AGENDA
PLAN COMMISSION MEETING
Thursday, June 25, 2020 at 7:00 p.m.
Jackson Village Hall
N168 W20733 Main Street
Jackson, WI 53037

BUILDING DESIGN FOR:
PROPOSAL 20-00115
W209N17145 INDUSTRIAL DR
JACKSON, WI 53037

STAFF REVIEW COMMENTS
Plan Commission Meeting – June 25, 2020

1. Planned Unit Development Amendment – Premier Rosewood Jackson PR3 – Sign – Rosewood Lane

L A R G E P R O J E C T S I G N

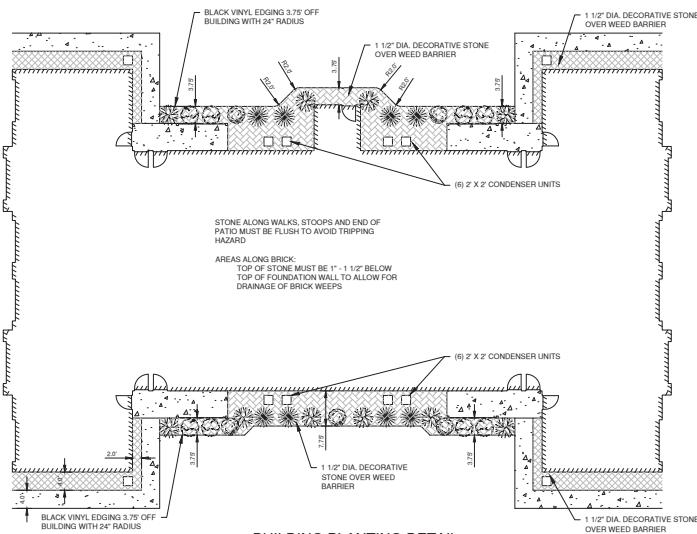
- Sign location indicated on plans is shown within the setback area. Sign should be relocated to comply with setback requirements.
- Plans do not indicate whether sign will be illuminated. Provide clarification on illumination, if any, and type proposed (i.e. back-lit, front, etc.).
- Plan application mentions a landscaping plan was included however; landscaping plans specific to the monument sign were NOT included in the submittal.

- Missing sign landscape plan. Sign should be properly located.

1 ARCHITECTURAL SITE PLAN
SCALE: 1" = 40'-0"

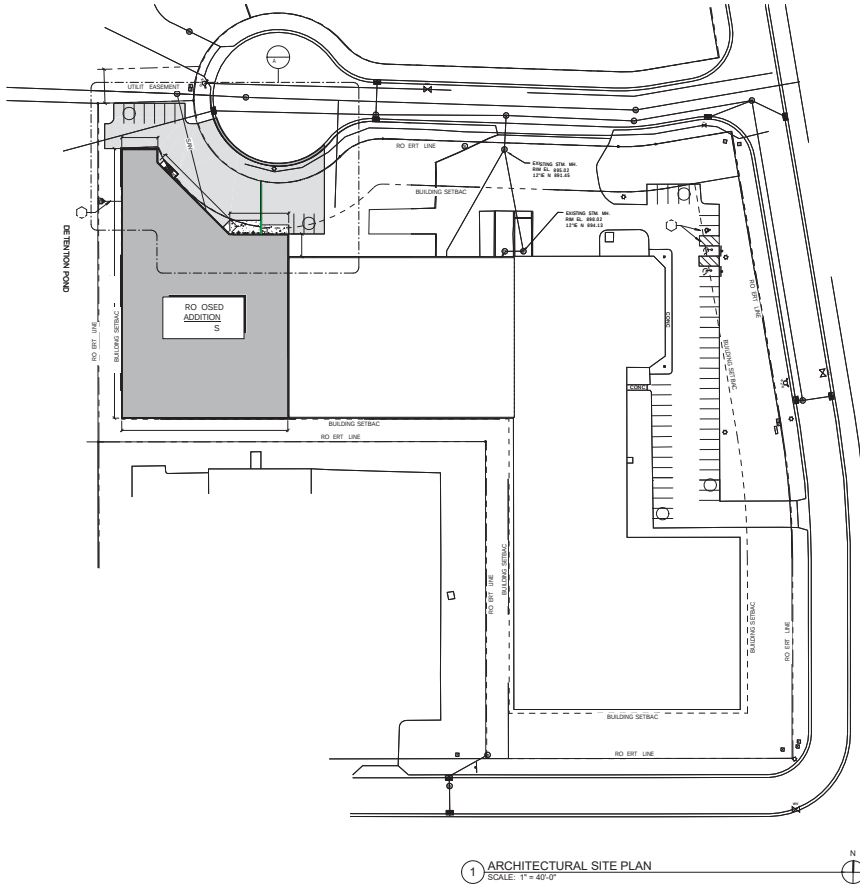
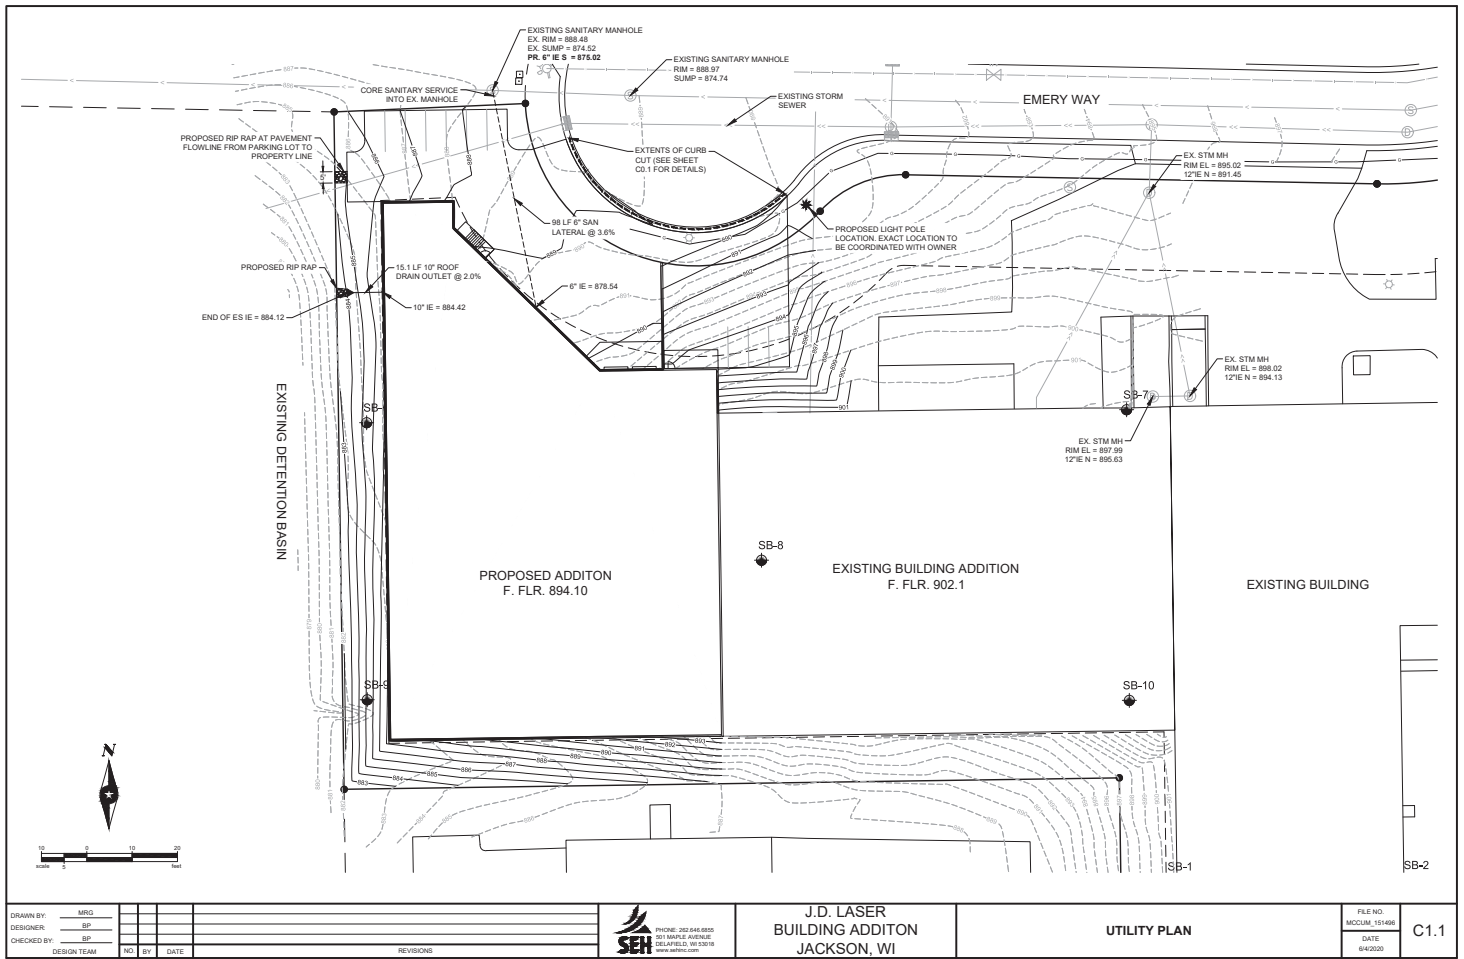
- Plans show pavement/parking and extended approach area proposed for the right-of-way areas abutting Emery Way. Staff discussed this with the owner in a preliminary meeting and has no objections to this. It should be noted that a light pole exists on the south side of the cul-de-sac and would need to be relocated to accommodate the proposed driveway and entry to the new loading docks. Owner to workout potential re-location with WE Energies directly.

- The sanitary lateral shall discharge into the sewer main and not in the manhole. If the sanitary sewer lateral is only for the new bathroom group, then no sampling manhole is required. If the sanitary lateral is provided for production, then a sampling manhole will be required.
- The Village will allow direct discharge into the regional pond, although, a Stormwater Management Plan shall be submitted with the following criteria: calculation on the pre and post of storm runoff for 2 yr, 5 yr and 100 yr for the addition and the entire site.
